Subject: RE: E.C.O. building on hwy 190
Date: Wed, 4 Apr 2007 16:44:09 -0500
From: "Donna ODell" <dodell@cityofslidell.org>
To: "CHUCK DAMMON" <chuckdammon@yahoo.com>

RE: Commercial Development Site Review
__ Gause Boulevard West, Slidell, Louisiana

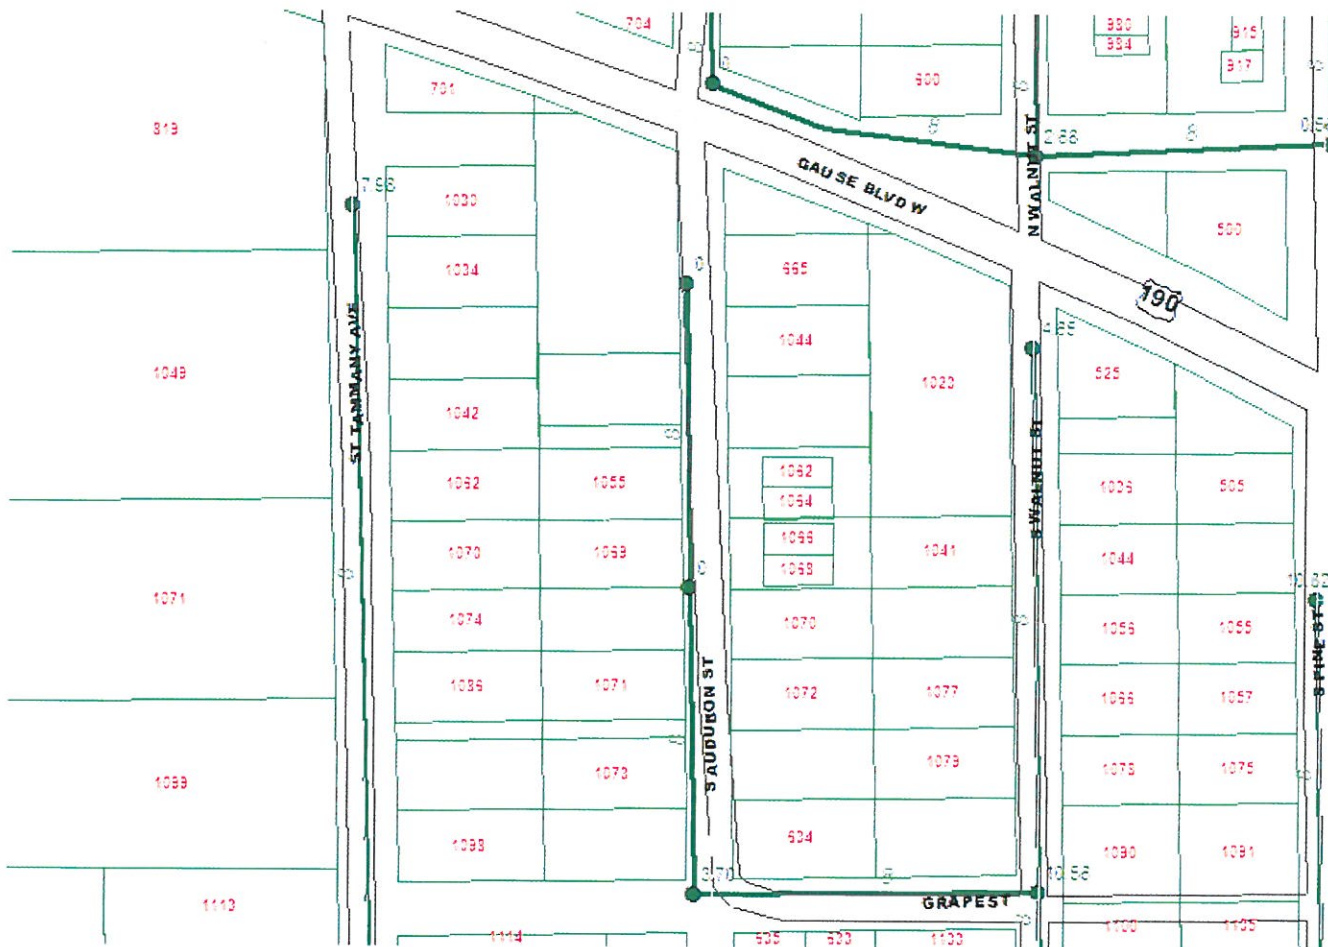
Hey Donna,
 Could you please email me the of the sewer and water locations for this site.
 I have attached a pdf file of the survey for you to see. Also, can I drain into the side street ditch for my drainage our do I need to drain into the ditch on hwy 190. And do I need to close all the ditch's in, front and side of the property.

I can't tell from the survey which lot you are talking about; however, all ditches in the city street right-of-way must be closed in. I'm not sure which side street ditch you are talking about, but if the ditch is in city right-of-way, you can drain into it - but the roadside ditch will need to be closed in. Draining to ditch on Hwy 190 would have to be approved by DOTD.

According to our GIS, here is the sewer (numbers by manholes are approximate invert elevations):
